Re: Environmental concerns about proposed fence impacting the integrity of Umstead State Park

PROJECT NAME: **ENHANCED SECURITY PERIMETER FENCING**
 FOR THE
RALEIGH-DURHAM AIRPORT AUTHORITY
 DRAWING TITLE:
OVERALL PLAN

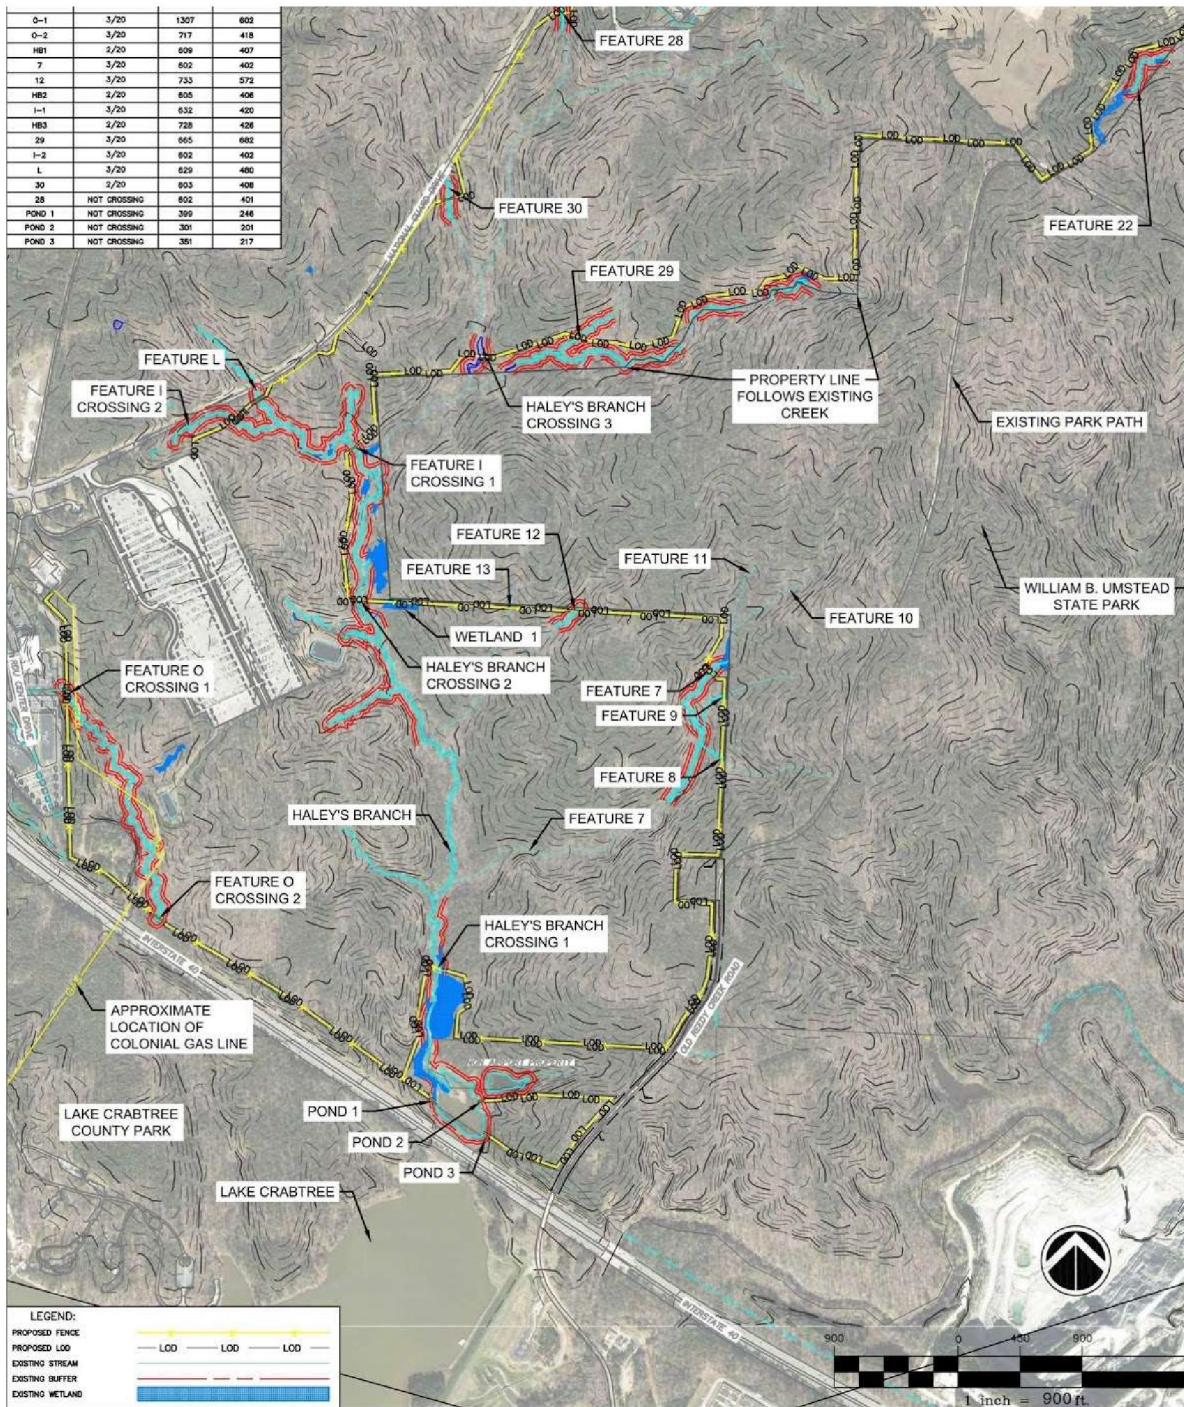
5. The fence as it is being proposed would still sever the public's access to the William B. Umstead State Park via the Reedy Creek Trail, which would also disrupt the East Coast Greenway and the US1 Bike routes. The attached graphic in the letter, which was submitted along with RDUAA's request to the DEQ, showed the fence severing the Reedy Creek Multi-use Trail being cut. (See: just south east of Feature 22).
